SECTION 7

Clarifications to the EA

This section contains clarifications to the I-25 Environmental Assessment, based on comments received during the review process. Clarifications are being made in three cases. The first clarification addresses water quality impacts. The second clarification corrects the description of boundaries for one historic resource. The third clarification provides a previously missing graphic that shows modifications needed to the I-25 easement on the U.S. Air Force Academy.

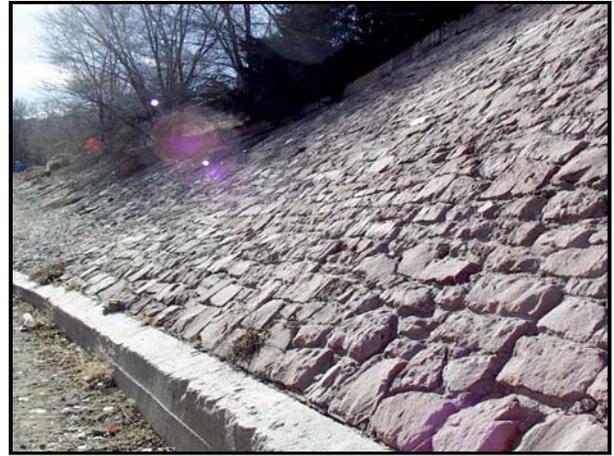
It was determined that the discussion of proposed modifications in the vicinity of the Bijou Street Entrance Gate to Monument Valley Park would be more complete if it more fully described the effects

on the pedestrian experience, including the issue of wheelchair accessibility to the historic park. Therefore a new paragraph addressing this matter has been added to page 3-118 of the EA.

Although there would be an adverse effect on the entrance gate area, the change in feeling, function and design would not be so great as to constitute a constructive use of an historic property or a substantial impairment of park uses. The addition of a retaining wall, steps and handrail would introduce a new design element that does not exist today, but this minor change would not have such an effect on the historic setting as to effect the eligibility of the entrance gate area or the park itself. Regarding park accessibility, the entrance gate would remain wheelchair-accessible from both Bijou Street and Westview Place via three other at-grade sidewalks nearby. Since the park entrance would remain open for pedestrian use and would continue to be wheelchair-accessible, the function of the park entrance gate and its adjacent park land would not be substantially impaired.

FIGURE 3-24a
United States Air Force Academy Easement Modification
Area at North Gate/Powers Interchange

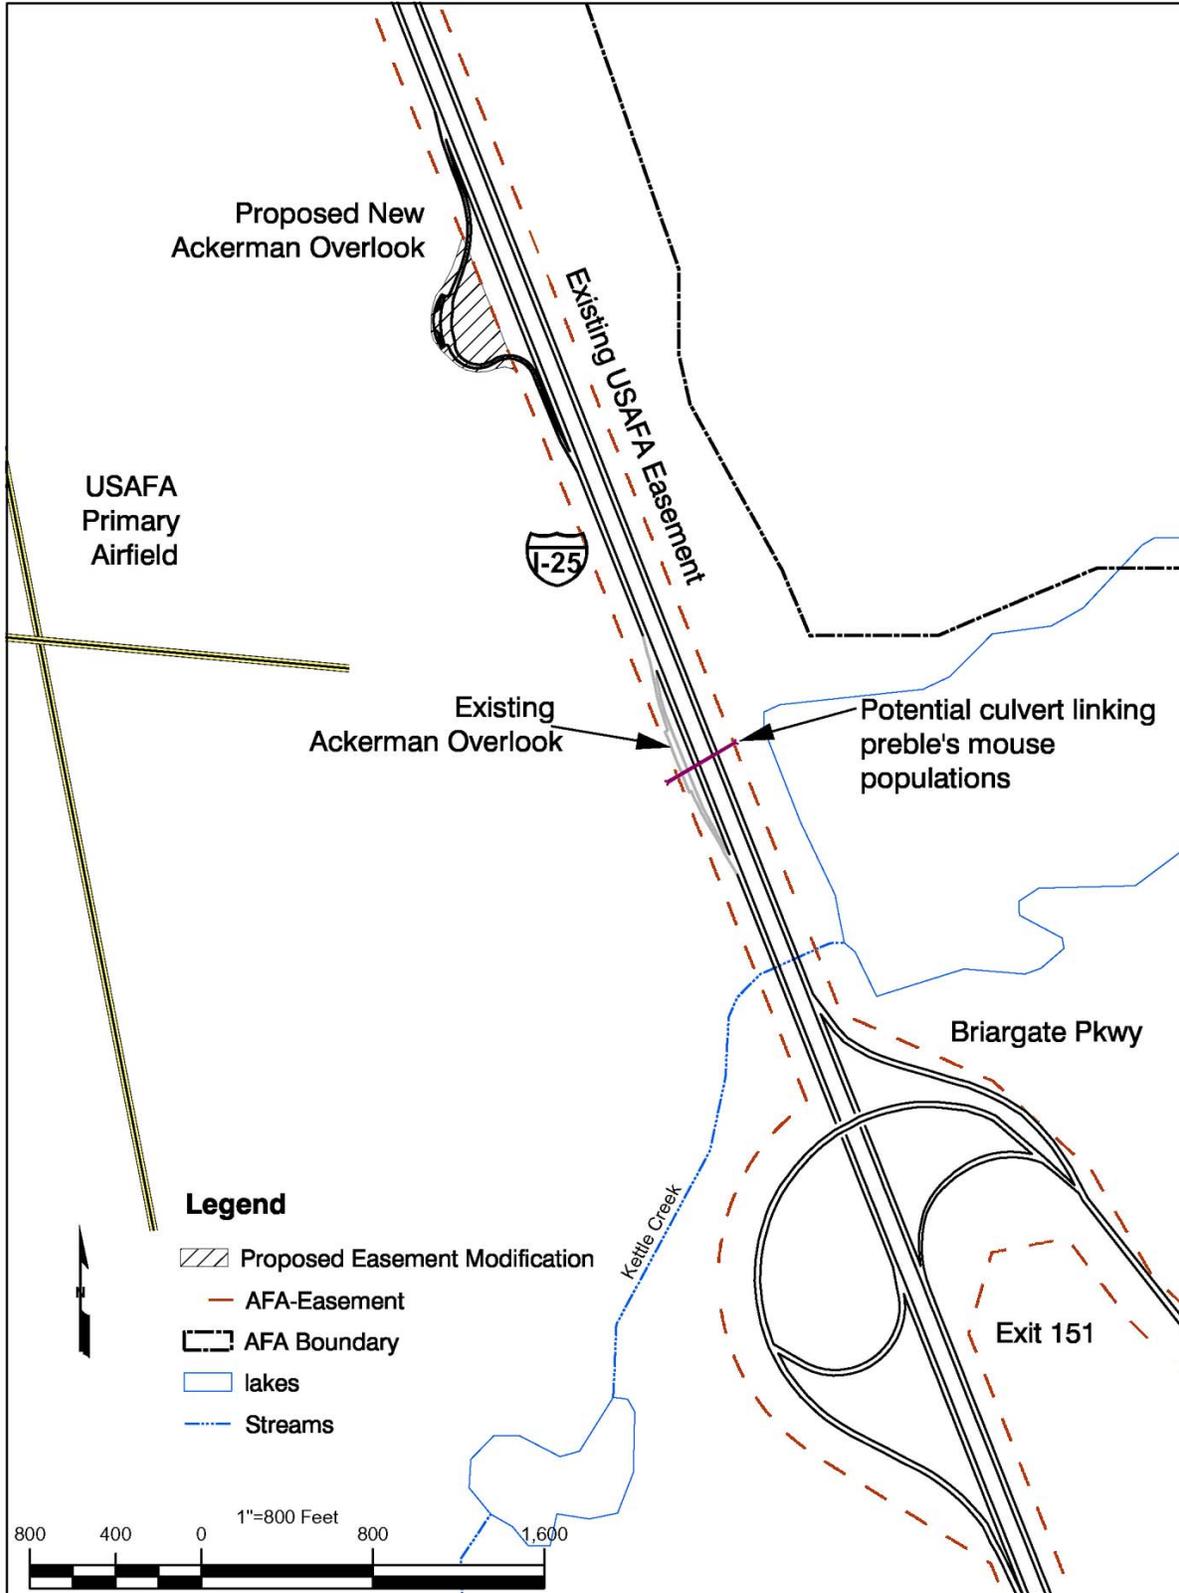
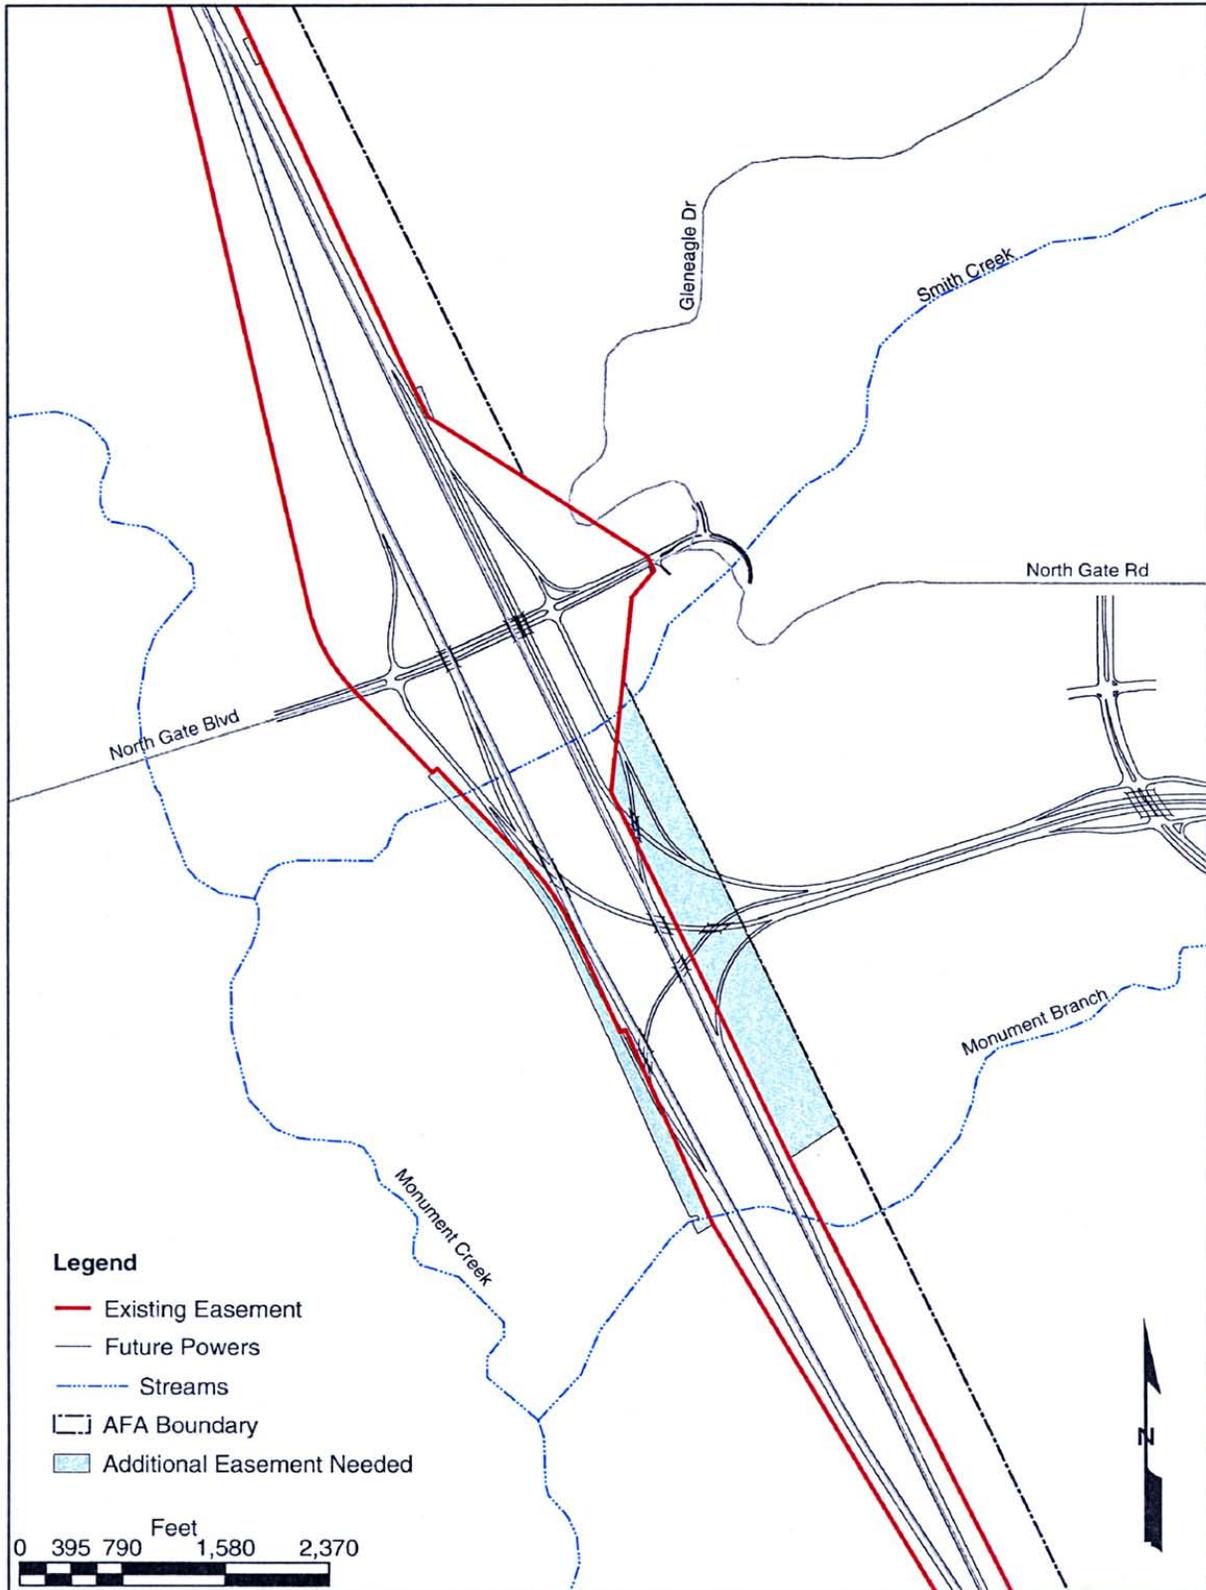
The U.S. Air Force Academy commented that the text on page 3-141 of the EA makes reference to two different figures, both designated as Figure 3-24. The EA first states that Figure 3-24 depicts the Air Force Academy easement expansion that would be needed in the vicinity of the North Gate/Powers Interchange. Then, in the next paragraph, the EA states that Figure 3-24 illustrates the existing and proposed sites of the Ackerman Overlook.

The first figure was inadvertently omitted. The omitted figure has been added and is designate as Figure 3-24A. The second figure, originally labeled Figure 3-24, has been renumbered as 3-24B. A corresponding change to the text on page 3-141 has been made.

Implementing the Proposed Action would require the use of additional Air Force Academy land for added highway lanes and for the extensive new ramp system planned for the North Gate/Powers Interchange. The existing I-25 easement comprises approximately 658 acres for the entire seven miles of I-25 on Air Force Academy lands. This easement would need to be expanded to include an additional 48.4 acres for the North Gate/Powers Interchange. This needed expansion is depicted in Figure 3-24a.
